Re: Technical Review
Class I Underground Injection Control (UIC) Permit Application

Subject: Response to Questions from the Technical Review of the Class I Underground Injection Control (UIC) Permit Application – February 7, 2005

HILMAR CHEESE COMPANY
Underground Injection Project
Waste Front Map
POSTED WELL DATA
WELL SYMBOLS
REMARKS
Attachment 2
BY: Pacific Geophysical Inc. 8/8/87
0 2000 4000 FEET
DATE: 12/20/87

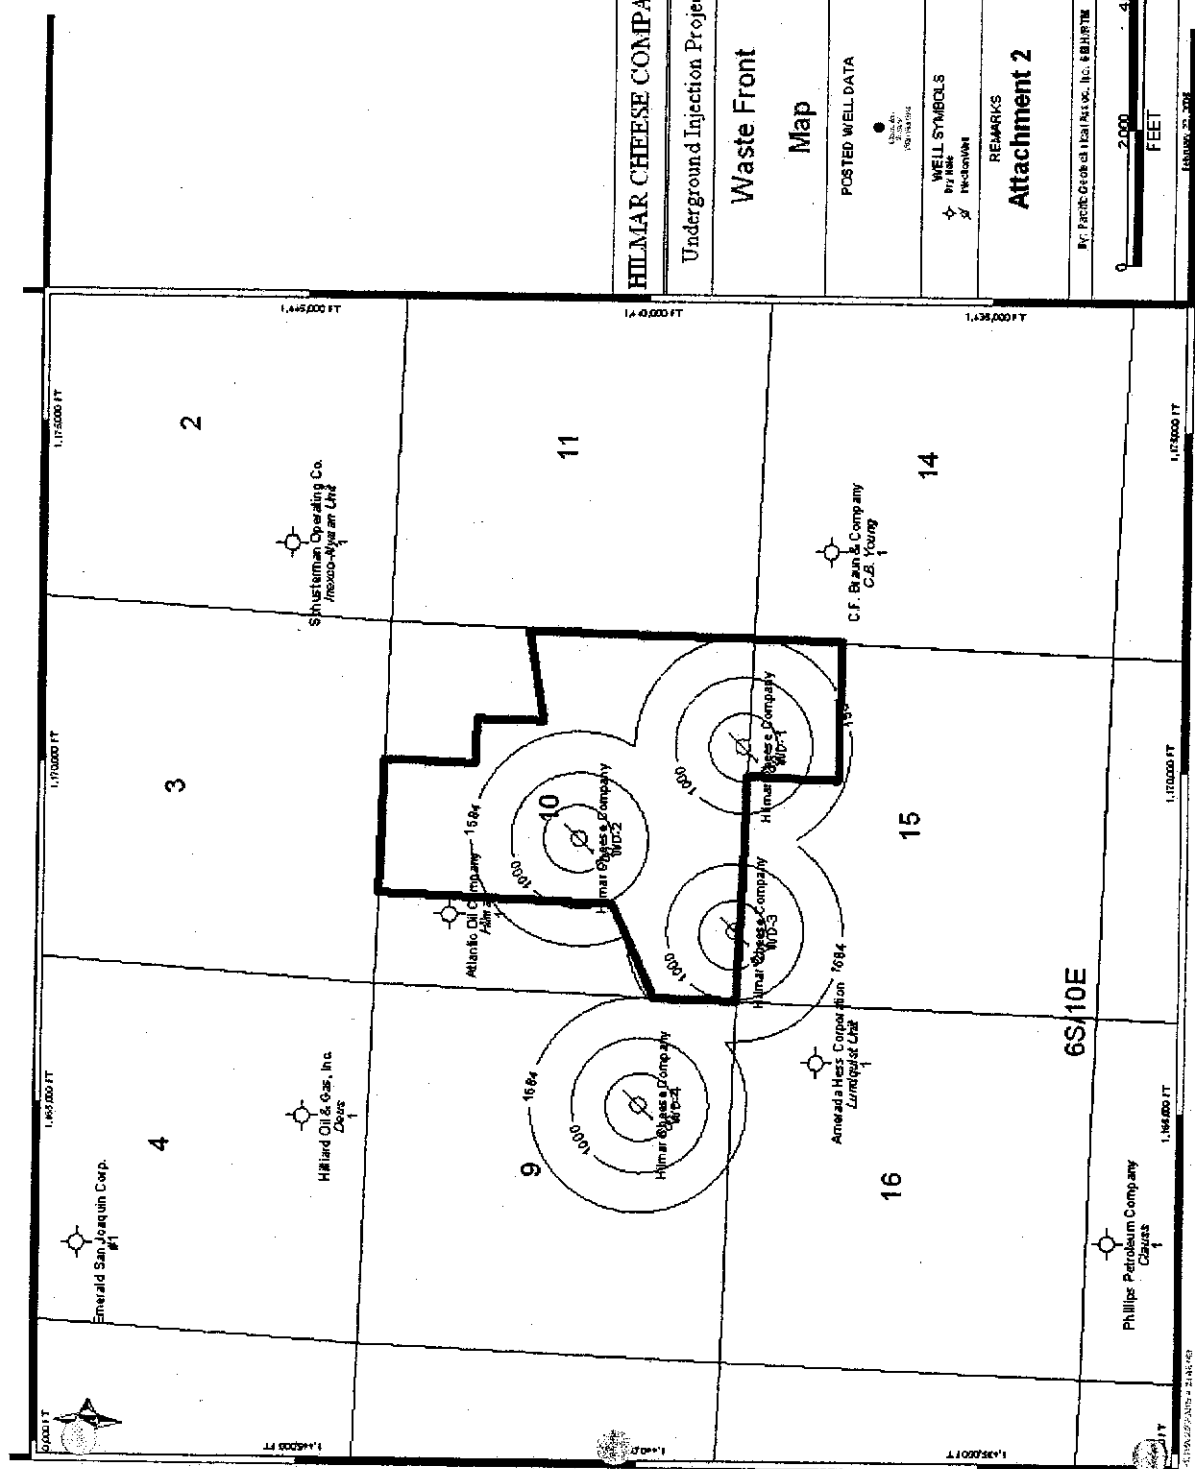
3. It appears the waste front radius and pressure front calculations from Attachment 16 were plotted individually on Attachment 2's Base Map for the Area of Influence. Pressure transient models for injection wells in close proximity are additive and should be calculated and plotted accordingly. Please either 1) verify that Attachment 2's Base Map for the Area of Influence is based on additive pressure transient calculations, or 2) create a new Base Map for the Area of Influence representing a plot of additive pressure transient calculations for all injection wells proposed in this permit.
4. Expand upon the justification provided in the application for using the permeability value of 500 millidarcies in the pressure transient calculations for the Paleocene-Cretaceous sand formation.

3. Attachment 2 of the Hilmar Cheese Company UIC Permit Application shows the area of influence for the waste front after 30 years using a maximum injection rate of 13,125 bbls per day. Attachment 3 and Attachment 4 show the revised pressure front based on the maximum injection rate.
